MILITARY SPECIFICATION

CIRCUIT CARD ASSEMBLY: 10547240
(TARGET COUNTER, MEMORY AND READOUT - A4)

This amendment forms a part of Military Specification MIL-C-60579(MU) dated 18 June 1970.

FIGURE 2
EXTERNAL TEST CIRCUITS

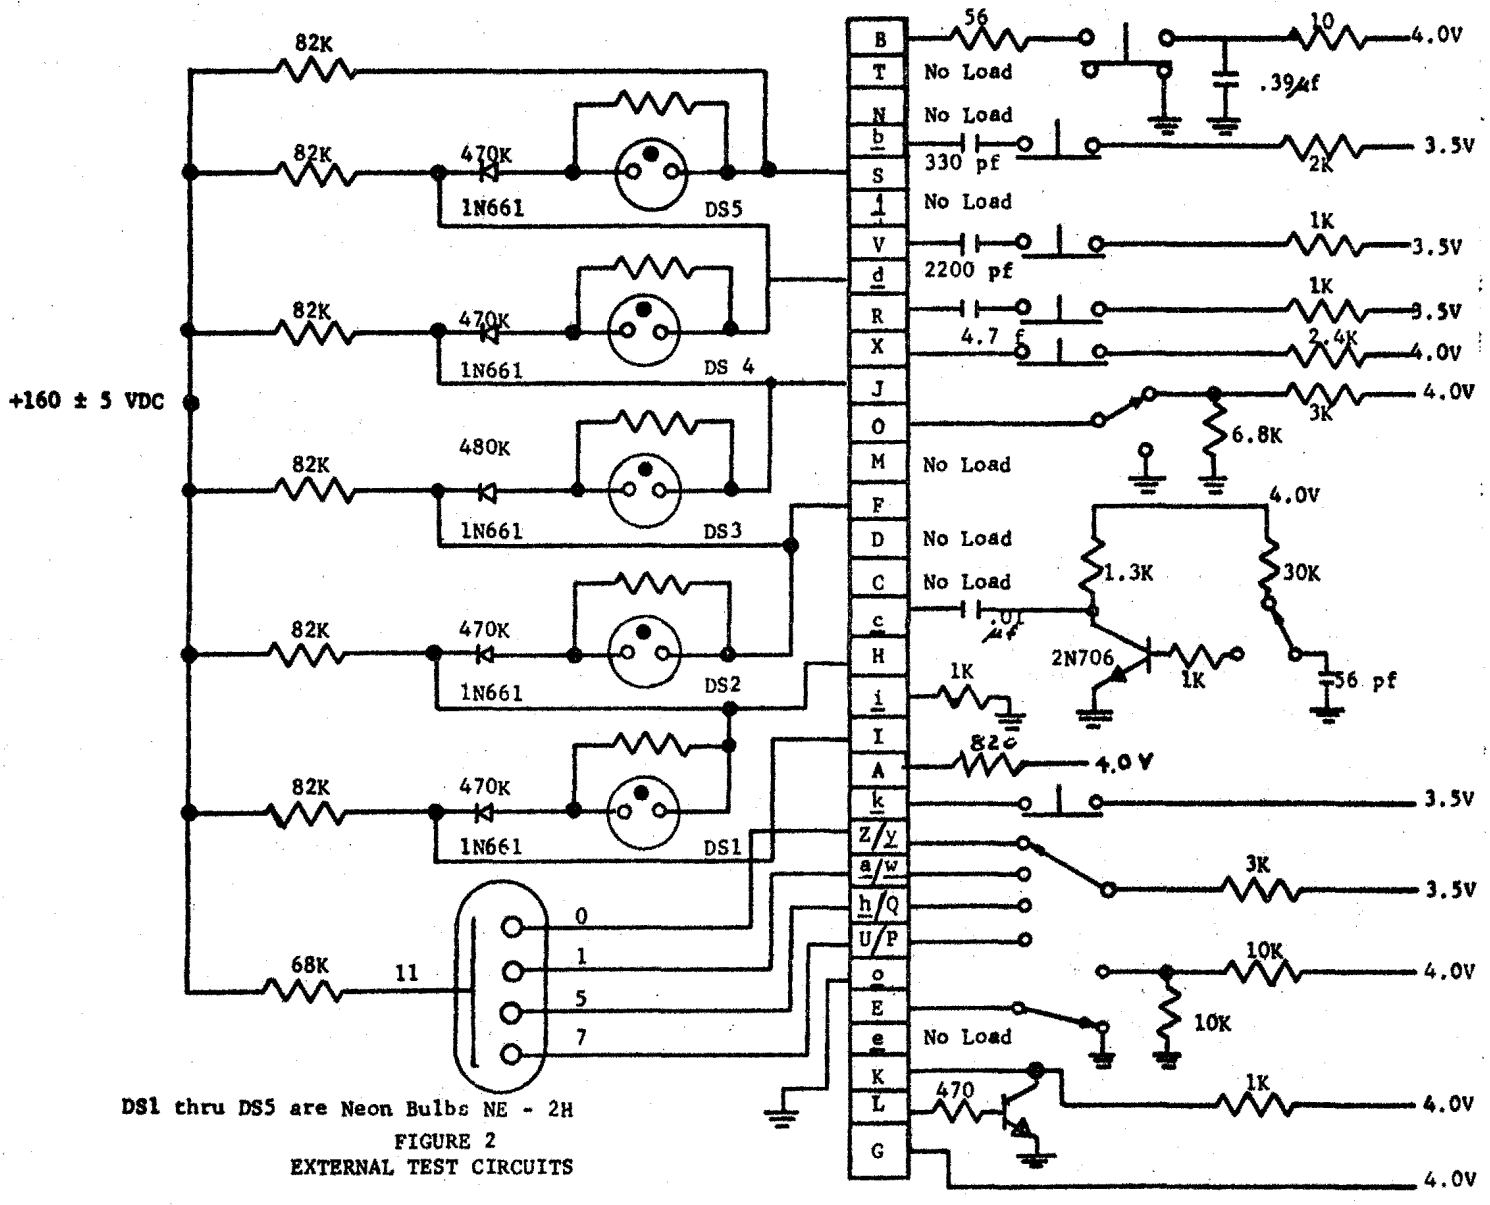
Page 16, Figure 2: Delete and substitute new figure.
